Access Compliance Report

Public Rights-of-Way

Intersection ID: 19991	Main Street: NATIONS_FORD_RD	Cross Street: REGENCY_EXECUTIVE_PARK_DR	Location: NE
ADA ID: CA13548367E9	Ramp Type: PerpDiag	Initial Pass/Fail: Fail	Overall Compliance: No
Severity Score: 22.5			
Codes/Mitigation Info/Possible Solution		Field Measurements/Component Compliance

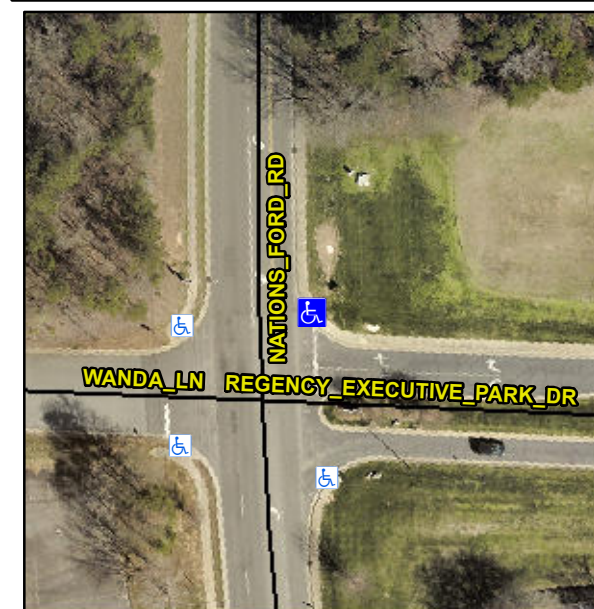
R304.5.1, R304.2.2, R304.5.3

Compliance	Description	Data	Compliance	Description	Data
N/A	Ramp Length (in)	57.5	No	Ramp Slope (%)	9.1
No	Ramp Width (in)	47.0	No	Ramp XSlope (%)	3.9
N/A	Flare Type LT	N/A	N/A	Flare Type RT	N/A
N/A	Flare Slope LT (%)	N/A	N/A	Flare Slope RT (%)	N/A
N/A	Flare Traversable LT?	N/A	N/A	Flare Traversable RT?	N/A
N/A	Landing Length (in)	N/A	N/A	DWS Provided?	N/A
N/A	Landing Width (in)	N/A	N/A	DWS Contrast?	N/A
N/A	Landing Slope (%)	N/A	N/A	DWS Length (in)	N/A
N/A	Landing X Slope (%)	N/A	N/A	DWS Full Width?	N/A
N/A	Landing Curb? (Y/N)	N/A	N/A	DWS Offset (in)	N/A
N/A	Shared Landing?	N/A			
N/A	Gutter Ponding?	N/A	N/A	Gutter Slope (%)	N/A
N/A	Gutter Lip Ht (in)	N/A	N/A	Gutter X Slope (%)	N/A
N/A	Painted X Walk1?	No	N/A	Painted X Walk2?	No
	X Walk 1 Direction	To W		X Walk 2 Direction	To S
N/A	X Walk 1 Width (in)	N/A	N/A	X Walk 2 Width (in)	N/A
	X Walk 1 Slope (%)	4.8		X Walk 2 Slope (%)	0.5
	X Walk 1 X Slope (%)	2.8		X Walk 2 X Slope (%)	7.1

Remove & Replace Curb Ramp With Two New Directional Ramps or Equivalent.
